City of Surrey
PLANNING & DEVELOPMENT REPORT

File: 7910-0321-00

Planning Report Date: July 23, 2012

in order to permit the development of a gas station on a commercial shopping centre site in Grandview Corners.

LOCATION PLAN SCALE: 1:1500

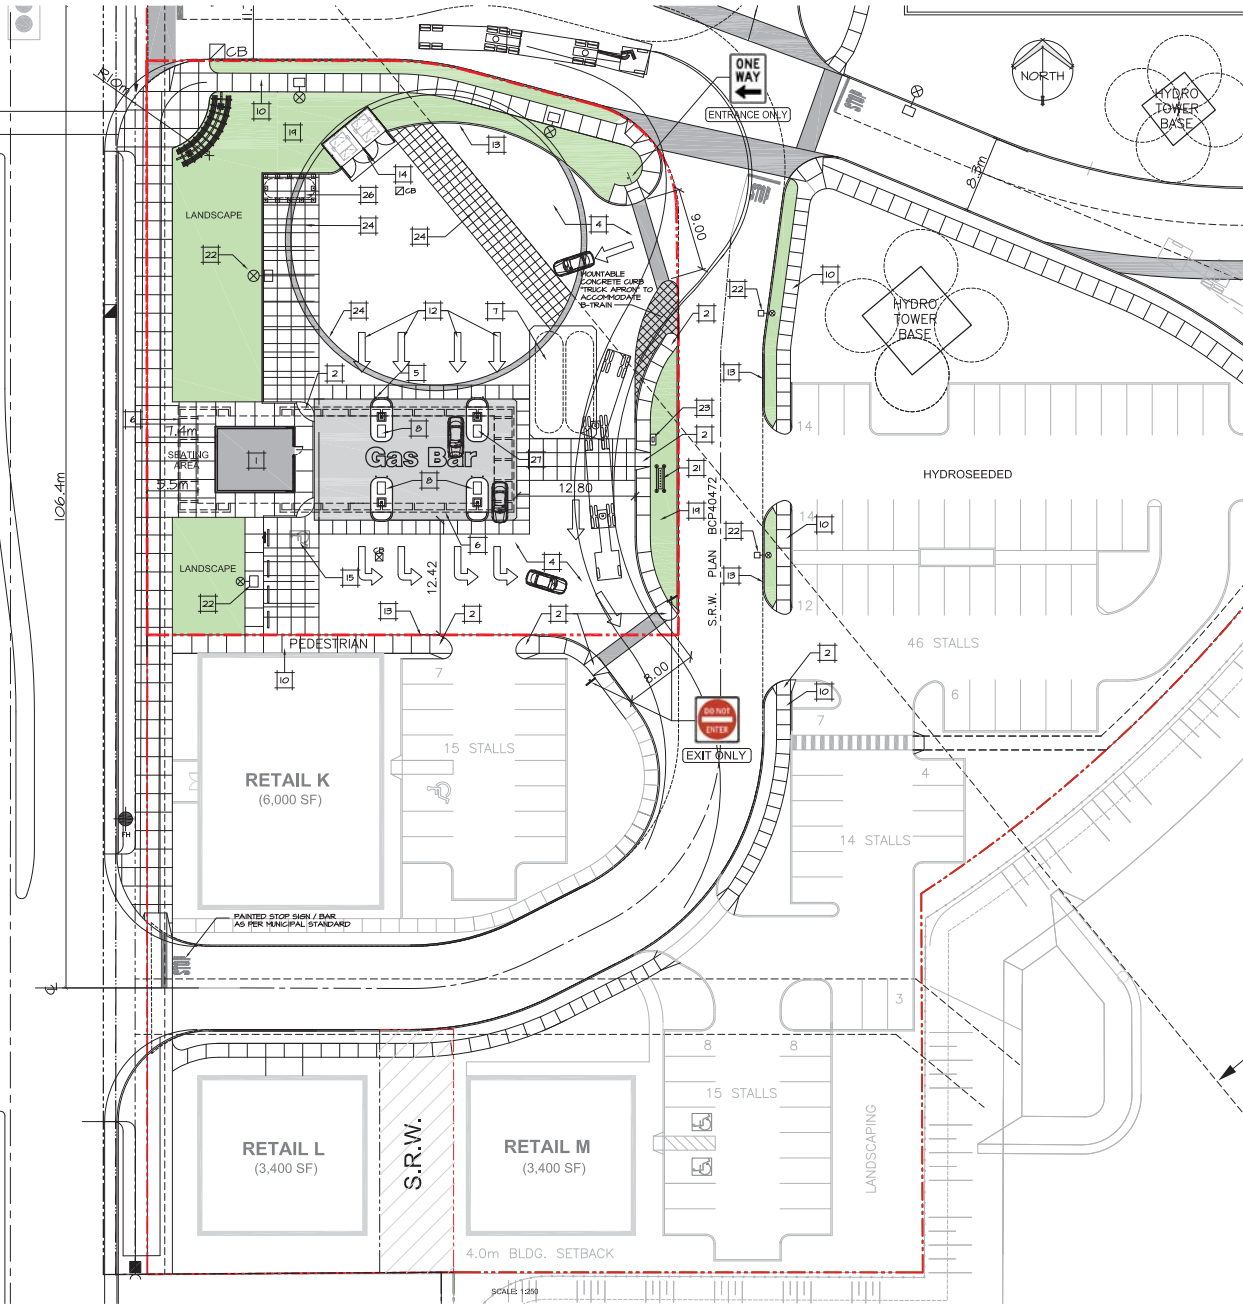
- The proposal requires a variance to the side yard on flanking street (160 Street) setback requirement, from 12 metres (40 ft.) to 7.4 metres (24 ft.) and a variance to the height requirement, from a maximum of 6 metres (20 ft.) to 8 metres (26 ft.).

- To reduce the minimum side yard setback on flanking street (160 Street) for principal and accessory buildings and structures for Block E of the CD Zone (By-law No. 15611) from 12 metres (40 ft.) to 7.4 metres (24 ft.).

- The applicant is providing a landscaped seating area adjacent to 160 Street and the Pioneer Greenway which gives the gas bar a relationship with the street and greenway. This will encourage pedestrians and bicyclists to use the amenity; for example, they may wish to purchase a drink from the gas bar kiosk and/or sit in the outdoor seating area. Because the facility has more of a relationship with the street and greenway than originally anticipated, the requested setback variance, to allow the building to be closer to the street, is considered appropriate.

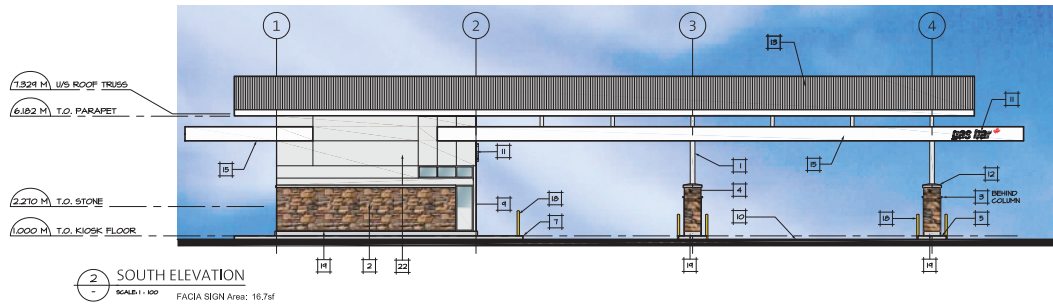
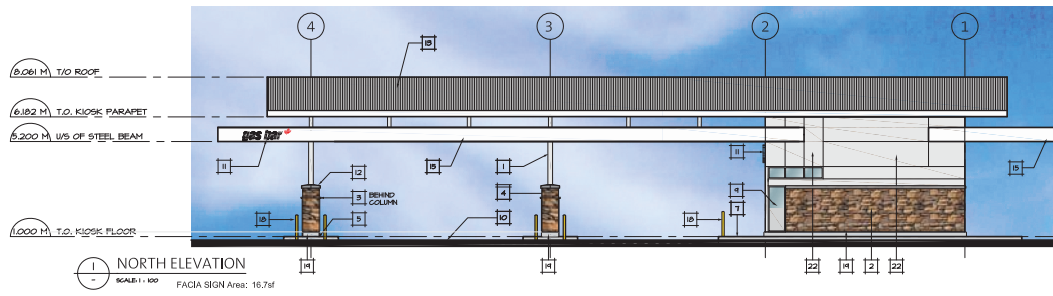
- To increase the maximum height for the principal building and pump island canopies for Block E of the CD Zone (By-law No. 15611) from 6 metres (20 ft.) to 8 metres (26 ft.).

- The increased building height is proposed to achieve the architectural roof curve geometry.

- The design of the building has been reviewed by City staff, including the City Architect and Urban Designer, as well as the Advisory Design Panel (ADP). The building height is considered to be acceptable from an architectural and urban design perspective.

DRAWING TITLE:
**LANDSCAPE
PLAN**

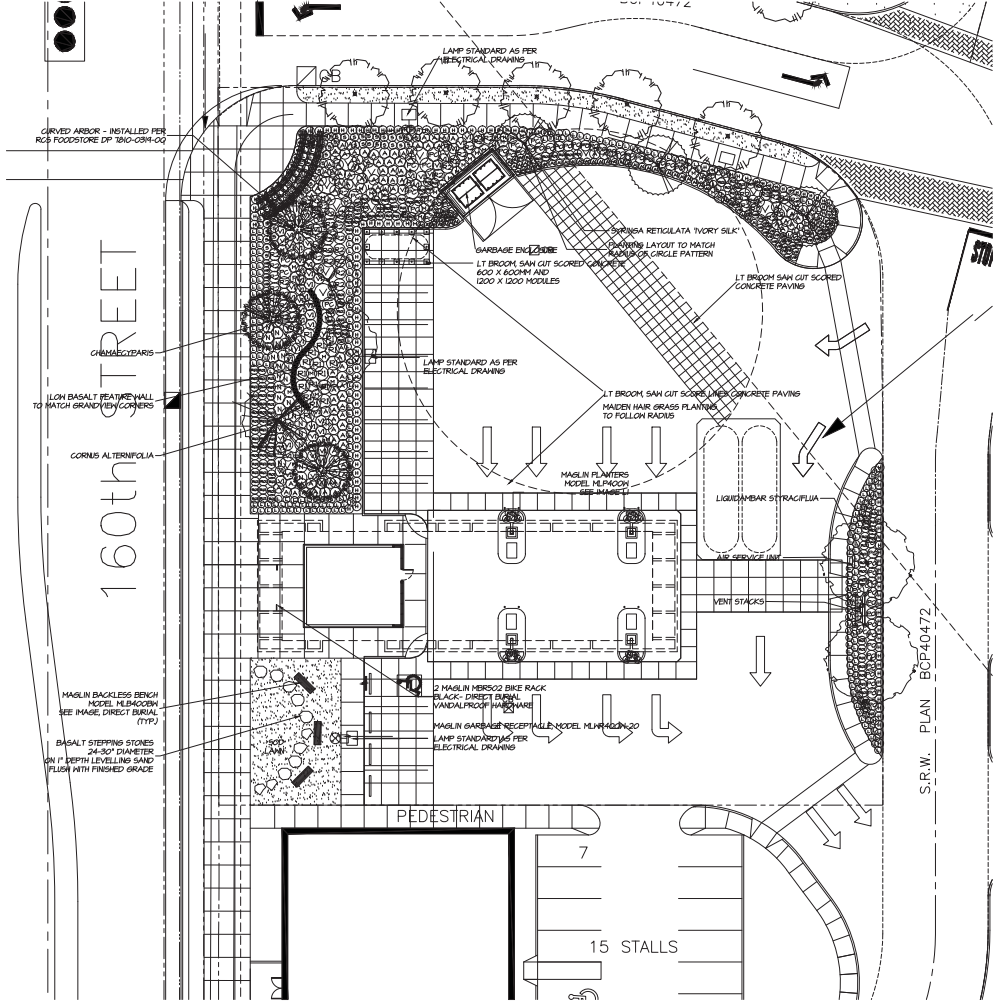
- The patterned stamped concrete within the vehicle queuing area north of the gas bar should reflect a grid-like pattern or playful elements not visually reference the adjacent powerlines.
(We have elected to leave as designed; the patterning on the paved area will provide visual relief and serve to break the large expanse as requested by the Urban Planner.)

- Low-level planting buffers located along the building exterior would create defensible space.
- The applicant may prevent loitering by expanding the sidewalk directly north and south of the proposed building with additional landscaping to provide greater continuity of greenspace.
(This was changed to suit.)
